3000 Series Update

3000/4000 Series **P2789** Diagnostics and Solenoid Valve Body Improvements

Casting Changes on **new valve body** – External Ribs

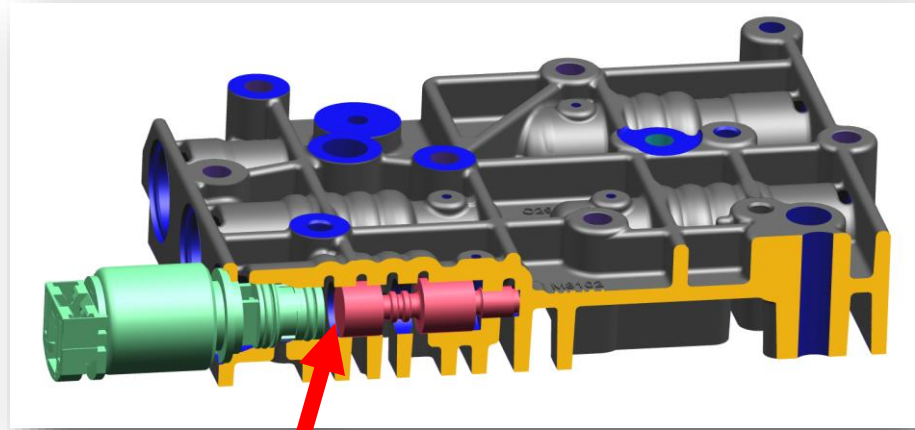
- Improved casting
 - *Increased ribbing from 3,5mm to 5,0mm in areas shown*
 - *Improved casting introduced January 2021*
 - *No SIL was published for this!!*

**Critical Bore
PCS3 (Typical)**

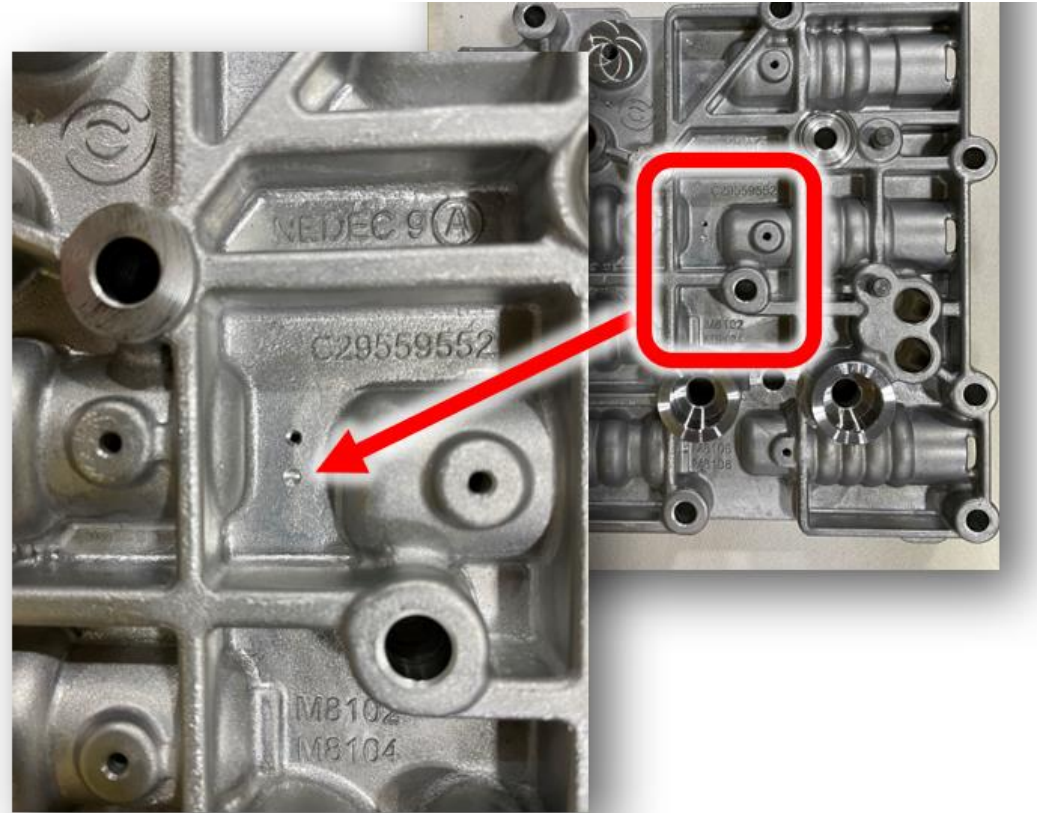
- Improved inspection method at manufacturer plant implemented in October 2020.
- “100% air gauge inspection” of critical diameter in PCS trim valve bores.
 - *Bore adjacent to solenoid valve.*

- “100% air gauge inspection” of critical diameter in PCS trim bores.
 - **Identification mark (Drill Point)** on all “100% air gauge inspected valve bodies”.

TID-B Aluminum Hauptventilblock

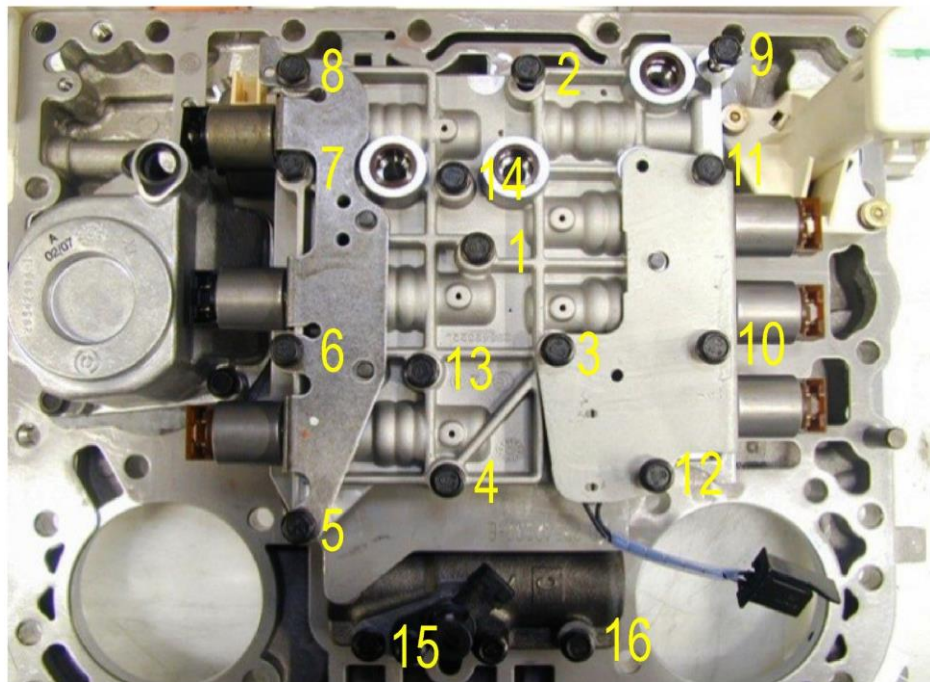
Geänderter Schraubenanzug:

M6: 10 – 13 Nm (wie bisher)

jedoch Anzug in 3 Stufen und Anzugsreihenfolge (Bild):

Stufe 1: Fingerfest.

Stufe 2: 5-7 Nm

Stufe 3: Endanzug 10-13 Nm
